Access Compliance Report Public Rights-of-Way (Curb Ramps)

Main Street: COMET_TRAIL		Cross Street: SOLSTICE_DR		Location:	S
ADA ID: RPAT211101103344	Ramp Type: Type 4 - Parallel	Initial Pass/Fail: Fail	Overall Compliance: No	Severity Score:	15

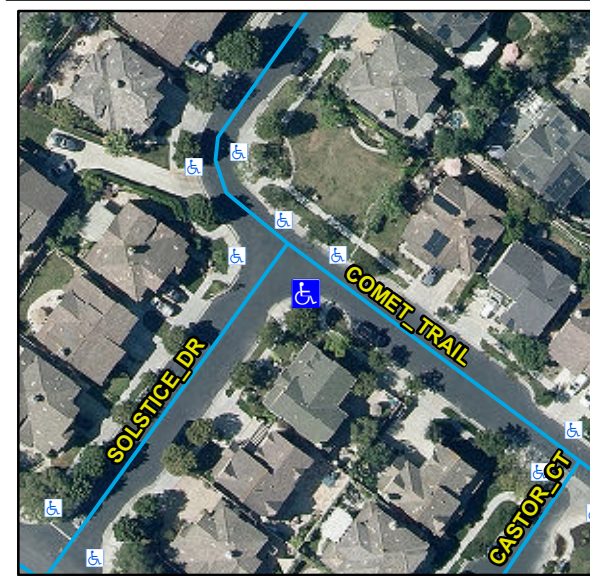
Compliance	Description	Data	Compliance	Description	Data
N/A	Ramp Length LT (in)	105	N/A	Ramp Length RT (in)	100
Yes	Ramp Width LT (in)	54	Yes	Ramp Width RT (in)	53
No	Ramp Run Slope LT (%)	8.4	Yes	Ramp Run Slope RT (%)	1.9
Yes	Ramp Cross Slope LT (%)	1.1	Yes	Ramp Cross Slope RT (%)	1.3
N/A	Landing Present	N/A	N/A	DWS Provided	N/A
N/A	Landing Length (in)	N/A	N/A	DWS Contrast	N/A
N/A	Landing Width (in)	N/A	N/A	DWS Length (in)	N/A
N/A	Landing Run Slope (%)	N/A	N/A	DWS Full Width	N/A
N/A	Landing Cross Slope (%)	N/A		DWS Offset Type	N/A
N/A	Landing Movement Obstructed?	N/A	N/A	DWS Offset Left (in)	N/A
	Landing Movement Type	N/A	N/A	DWS Offset Right (in)	N/A
N/A	Landing Shared	N/A			
N/A	Clear Space	Yes			
N/A	Clear Space To Crosswalk (in)	N/A			
N/A	Marked Crosswalk 1	No	N/A	Marked Crosswalk 2	No
	Crossing 1 Direction	NE		Crossing 2 Direction	NW
	Marked Crosswalk 1 Width (in)	N/A		Marked Crosswalk 2 Width (in)	N/A

Remove & Replace Curb Ramp With Two New Directional Ramps or Equivalent.
